County File # CDMS24-00015

The applicant requests Minor Subdivision permit approval for the division of a 0.517 acre lot. They are proposing three (3) parcels ranging from 6,798 sqft to 8,016 sqft. The subject property consists of lots 263, 264, and 265 of Tract 6013 in the Delta Coves area.

Subject: **Geologic Peer Review/ 30-Day Comments**
CDMS24-00015 / Owen Poole (owner)
Owen Poole, SDC Delta Coves, LLC (applicant)
APN 031-210-060 / 485 Halcyon Place (0.57 ac.)
Bethel Island Area, Contra Costa County
DMA Project #3019.24

Subject: **Geologic Peer Review / 2nd Letter**
CDMS24-00015 / Owen Poole (owner)
Owen Poole, SDC Delta Coves, LLC (applicant)
APN 031-210-060 / 485 Halcyon Place (0.57 ac.)
Bethel Island Area, Contra Costa County
DMA Project #3031.24

Figure 2: CDMS24-00015 USGS Geologic Map

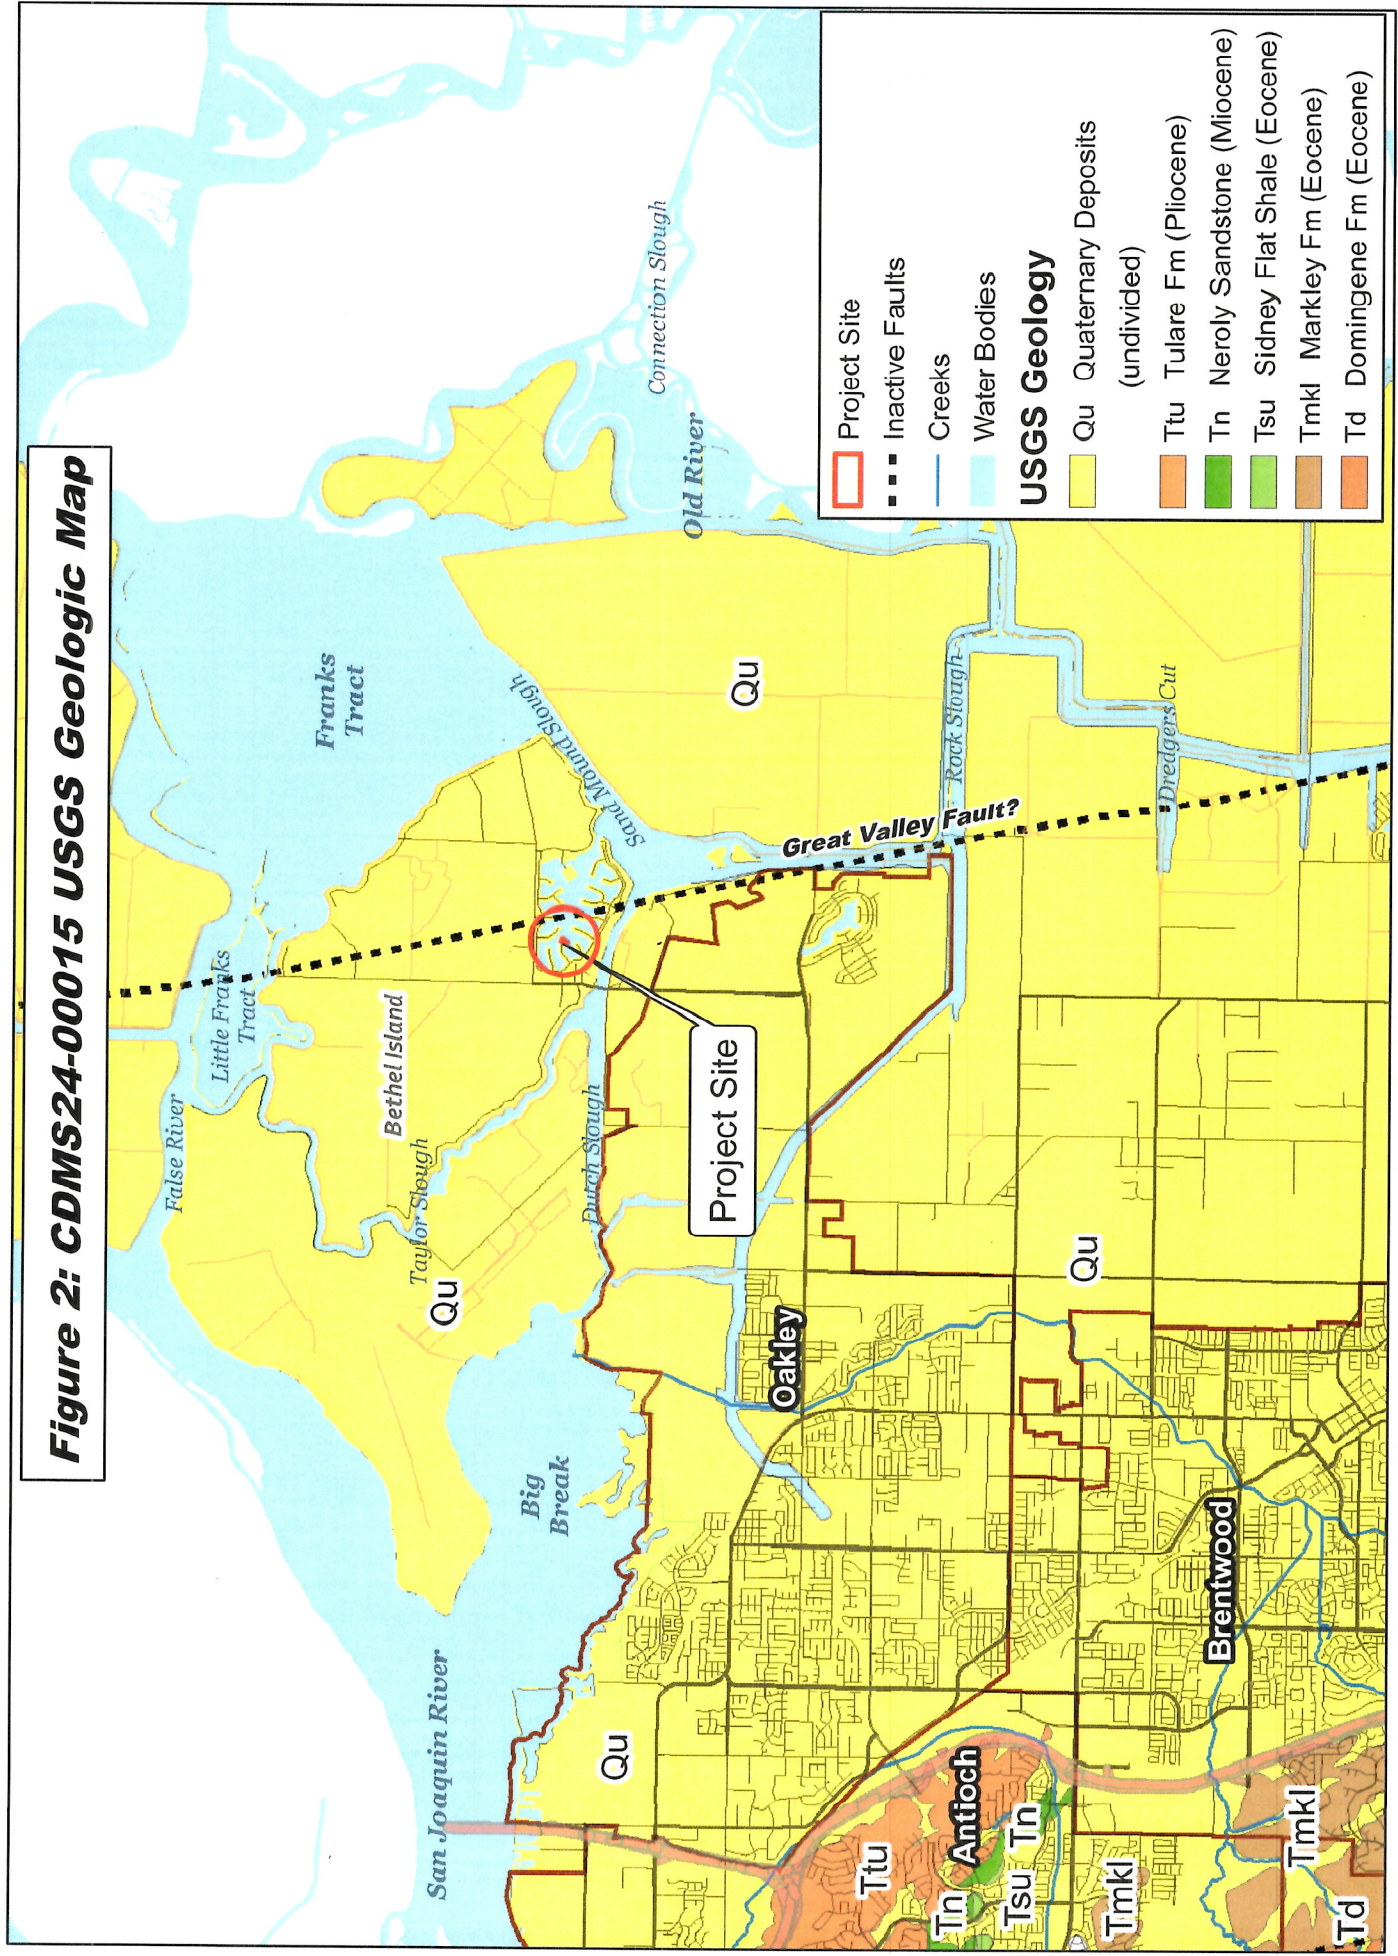
In 1994 the USGS issued a digitized bedrock geology map of Contra Costa County. Figure 2 presents a portion of this map. The base map shows the local road network and water bodies (blue color). The USGS maps the site and other lands on the valley floor as Quaternary deposits, undifferentiated (Qu). The nearest bedrock is indicated to be 7½ mi. southwest of the site. These formations range in age from Pliocene to Eocene. The depth to bedrock beneath the project site is unknown but may exceed 300 ft. below the ground surface.

Figure 3: CDMS24-00015 USGS Quaternary Geology Map

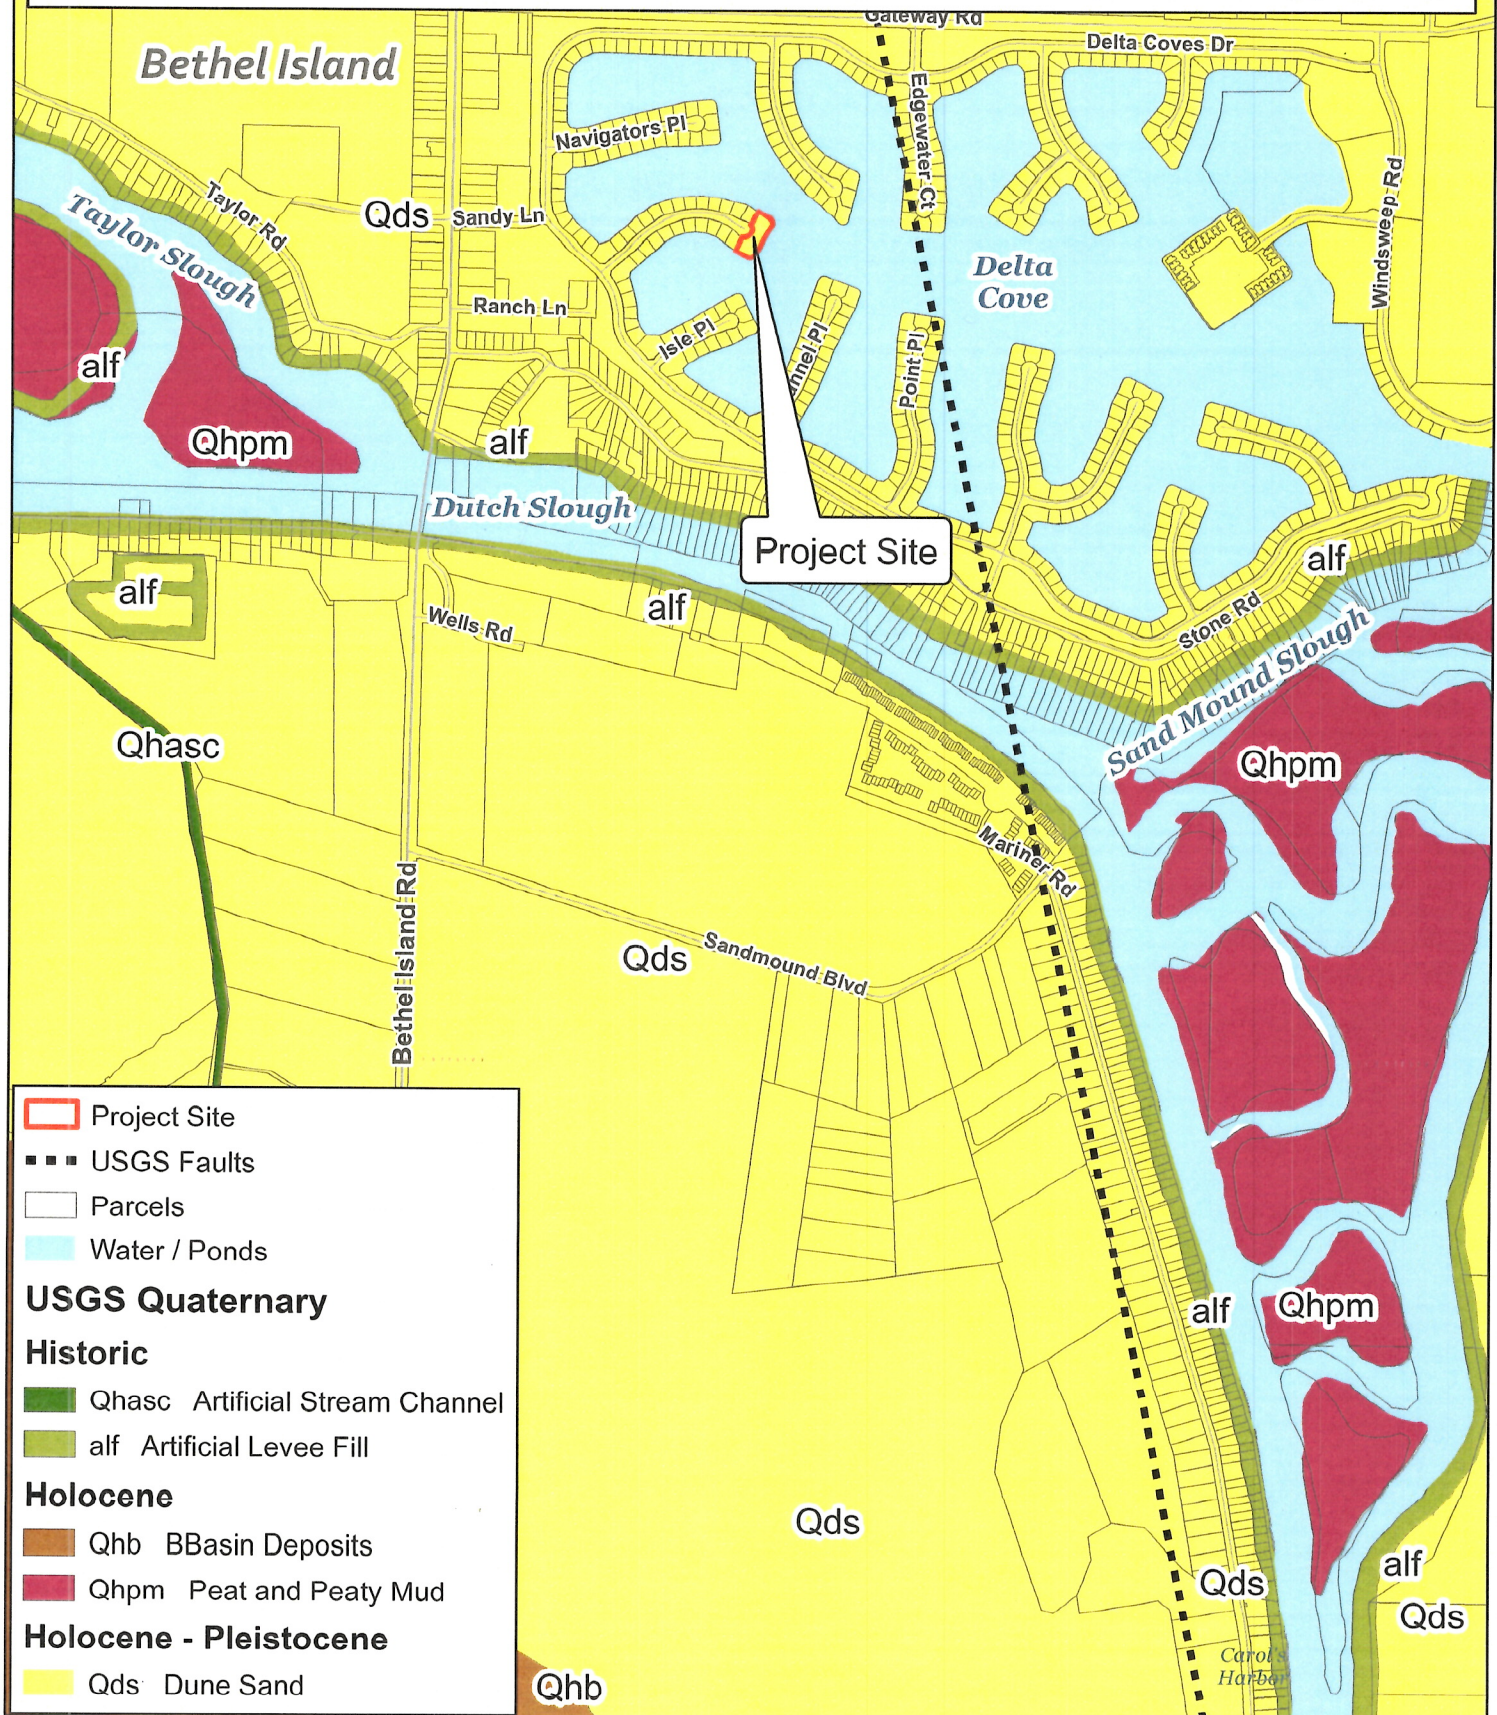
In 1997 the USGS issued a map that divided Quaternary deposits of Contra Costa County into nine categories that vary in age, depositional environment and engineering properties.⁵ A portion of this USGS map is presented in Figure 3 at a scale of 1 in.= 1,000 ft. Five different surficial deposit units are mapped on the Delta lowlands. The legend for Figure 3 divides these units into groups according to age (i.e. from Historic deposits to units of Holocene and Holocene/Pleistocene age). Table 2 presents a brief description of these units. According to Figure 3 the project site is located within an area mapped as *Dune Sand* (Qds). This unit is of Late Pleistocene and Holocene age. It consists of fine-grained, very well-sorted, well-drained eolian deposits. They occur mainly in two large northwest-southeast trending sheets as well as many small hills, most displaying Barchan morphology. Qds is inferred to have begun accumulating after the last interglacial high stand of sea-level began to recede about 71 ka and continued to form when sea level dropped to its Wisconsin minimum (estimated to be 18 ka), and probably ceased to accumulate after sea level reached its present elevation (est. to be 6 ka). The dunes display as much as 30 meters of erosional relief and in many areas, they are overlain by basin deposits (Qhb) and peaty mud (Qhpm) of Holocene age. Additionally historic deposits include *Artificial Levee Fill* (alf) and *Artificial Stream Channel* (Qhasc).

Figure 4: CDMS24-00015 Seismic Hazard Zone Map

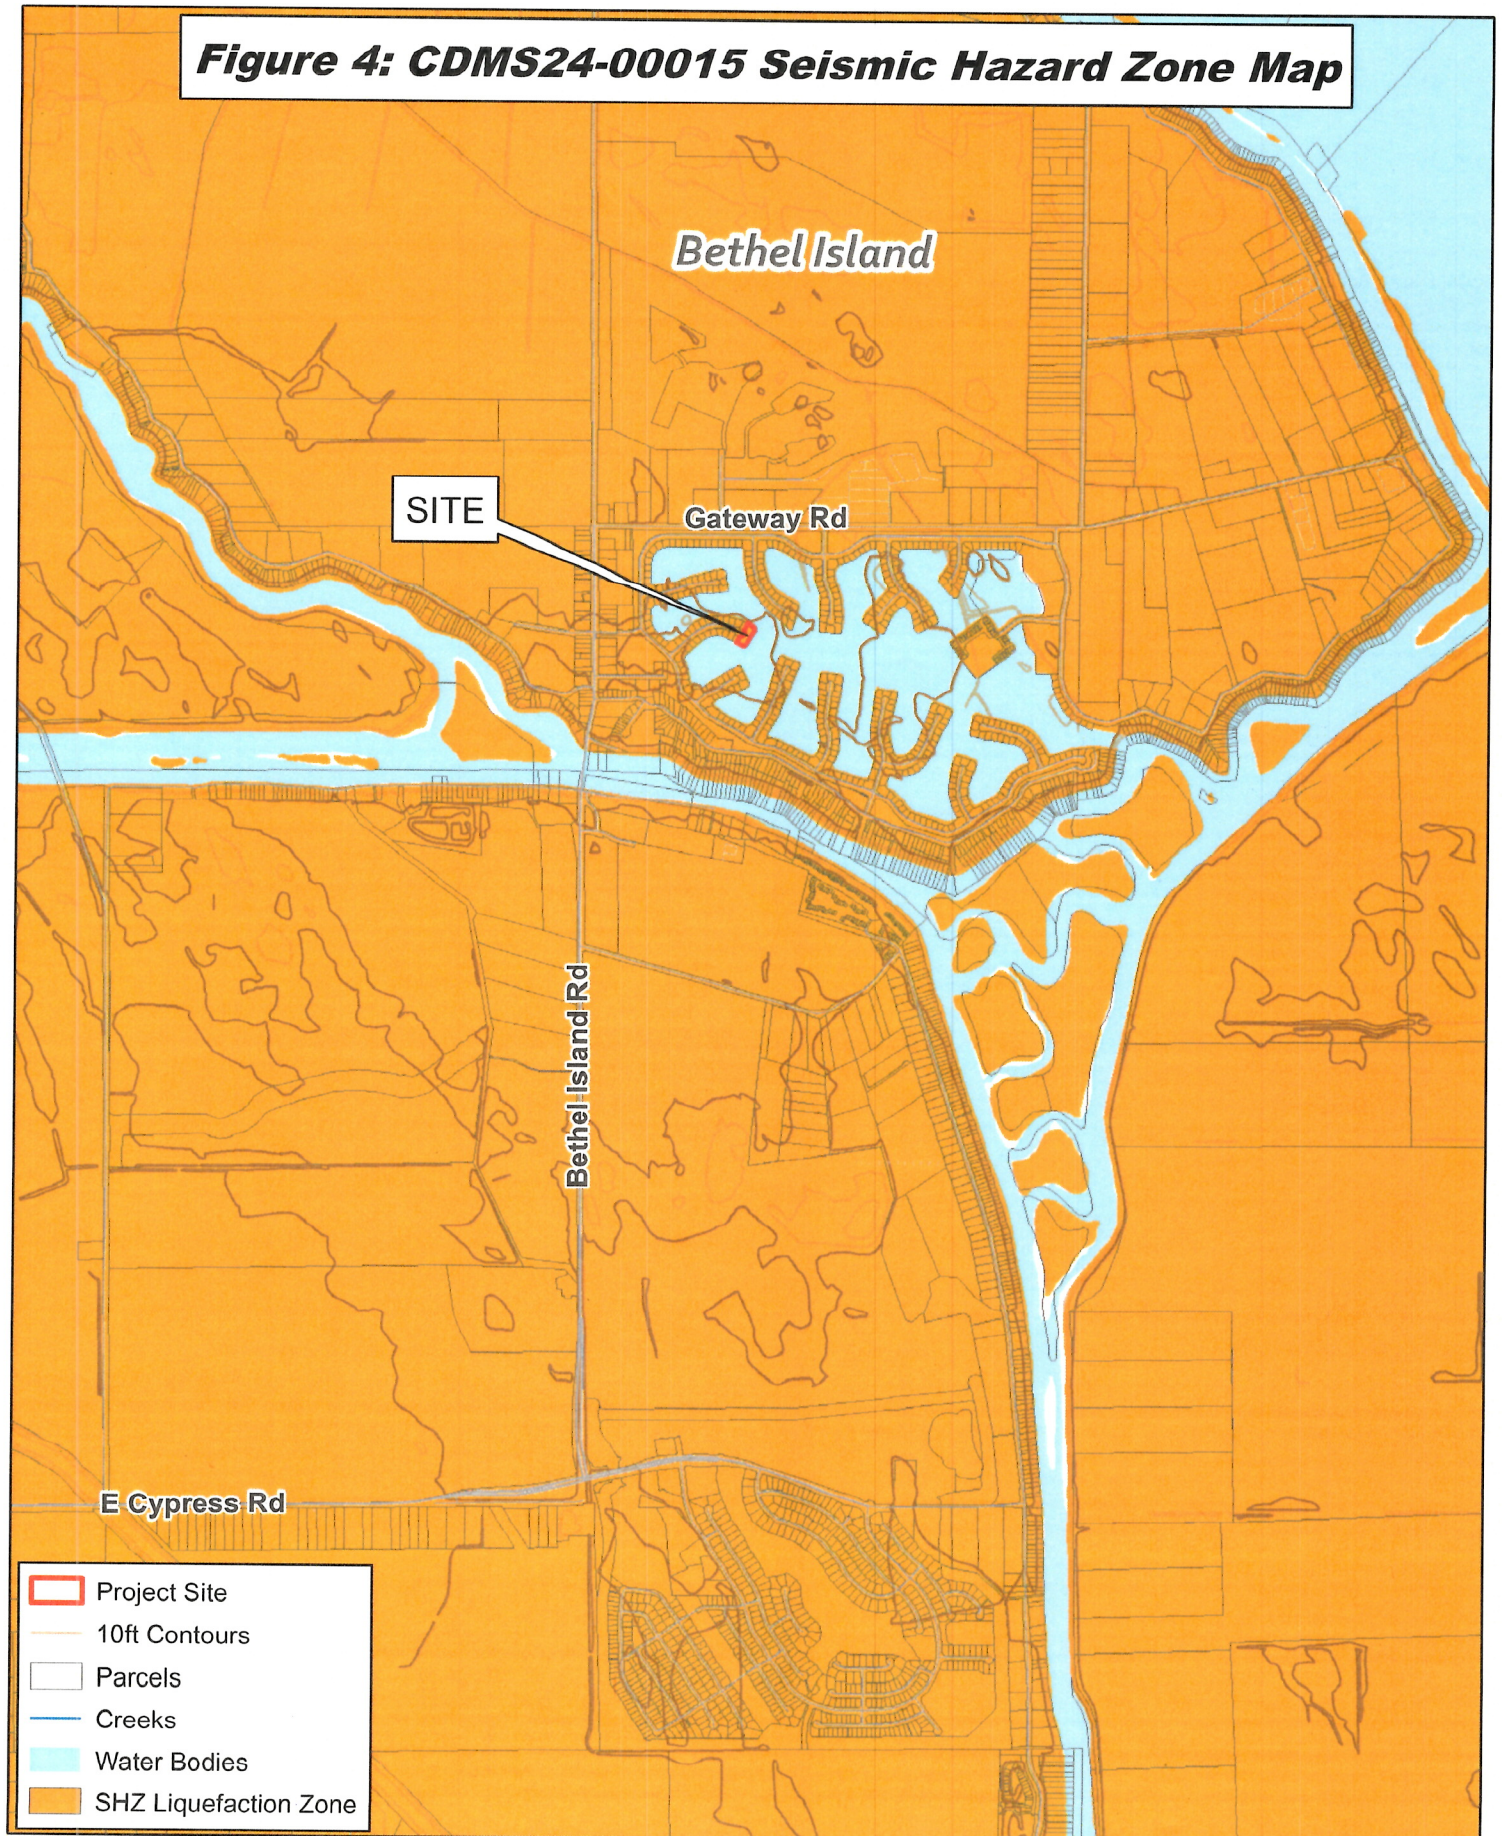
Figure 4 presents a portion of the Jersey Island 7.5-Minute Quadrangle. SHZ map showing the project site and vicinity (scale of 1 in.=2,000 ft.). This map was adopted by the State Mining and Geology Board on January 11, 2018. The boundary of the project site is shaded red and centered within a red bullseye; the base map shows the local road network, water bodies (blue) and topography (10 ft. contour interval). As shown, the project site is within an *Earthquake-Induced Liquefaction Zone*. In making its determination the CGS considers the engineering properties of the various Quaternary deposits known to occur in the subsurface, available information on the elevation of the water table, and local seismic conditions. In this

case, deposits known to occur in the subsurface are water saturated Dune Sand. The adopted SHZ map requires rigorous evaluation of liquefaction potential that follows guidelines presented in CGS Special Publication 117A.⁷ The SHZ Report provides background information utilized in preparation of the SHZ map, including the geology and seismicity of the Quadrangle map and the methodology used to provide evaluation of liquefaction potential. Using this approach, the CGS prepared a map that forecasts peak ground acceleration (PGA). That was used in the liquefaction analysis of the CGS. SHZ Report 121 (Plate 3.2) indicates that the Project Site is within an area rated as having a Probabilistic PGA of 0.23 - 0.24g's (i.e., 10% risk of exceedance in 50 years). For lands rated at-risk of liquefaction, there is a potential for permanent lateral and vertical ground displacements such that mitigation as defined in Public Resource Code Section 2693c is required. Disclaimer #8 on the SHZ map acknowledges that some sites within the designated hazard areas may have already been mitigated to standards of the local jurisdiction (i.e., the CGS has not performed exhaustive studies of previous geotechnical and engineering geologic reports).
